# Charlotte Historic District Commission Staff Review HDCRDEMO 2019-00421

Application for a Certificate of Appropriateness Date: August 14, 2019

**PROPERTY ADDRESS:** 408 Grandin Road

**SUMMARY OF REQUEST:** Demolition

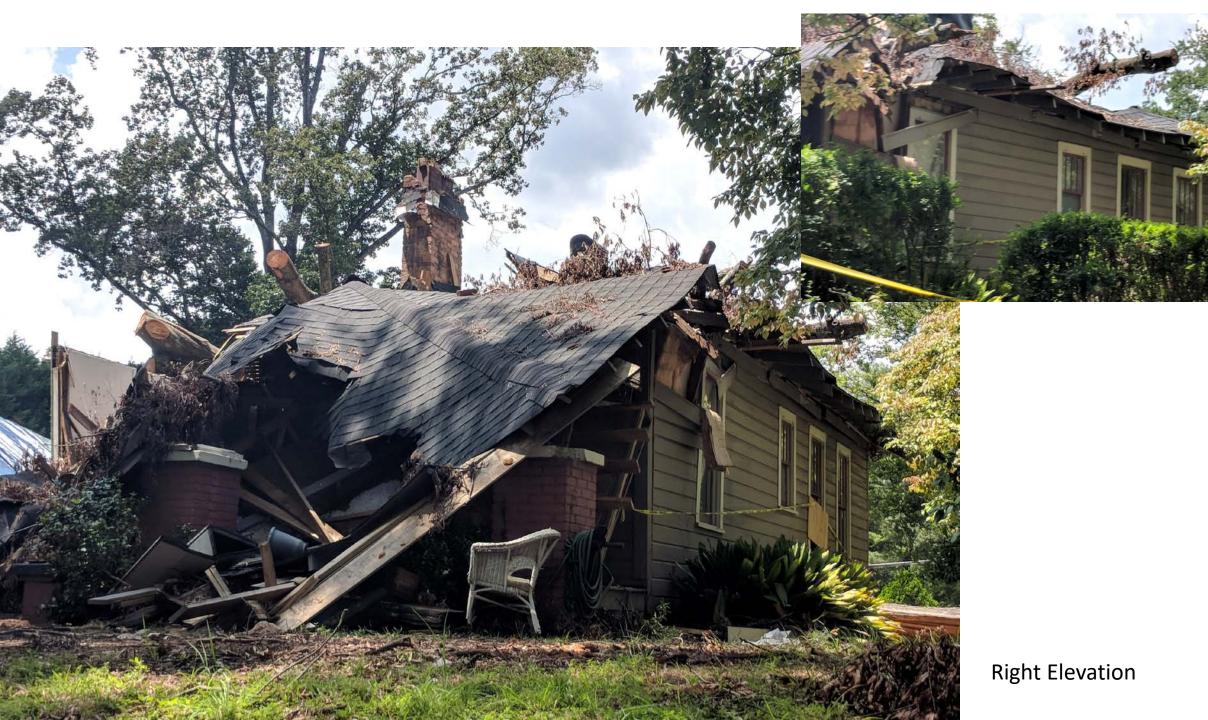
- The existing structure is a one-story single-family house constructed in 1925. Notable architectural features include a two-bay façade, entry with full-length sidelights and a tripartite window, a hipped roof that extends forward to rest on a three bungalow-style supports, a full-width engaged front porch, interior chimneys, and Craftsman-style 4/1 wood sash windows.
- The parcel is zoned R-5 and the lot dimension is 55' x 187.5'. Adjacent uses are single-family and multifamily residential.
- On July 2, 2019 a rear yard tree split and fell on the house destroying it. The only architectural elements that appear to be salvageable are a few original windows on the right and left elevations.

The proposal is full demolition of the house without a 365-day delay.

- 1. Per 10.4.1 of the Rules for Procedure staff recommends that this item be heard as a Consent Agenda item. If requested by a Commission member, or if an interested party has signed up to speak in opposition, then the HDC shall open the application for a full hearing.
- 2. Staff recommends Approval for the demolition of 408 Grandin without a delay due to the house being unsalvageable. The Commission may request that any original wood windows, trim, and other historic materials that are still intact on site be salvaged for subsequent reuse per the Design Guidelines for Demolition page 9.2, #8.
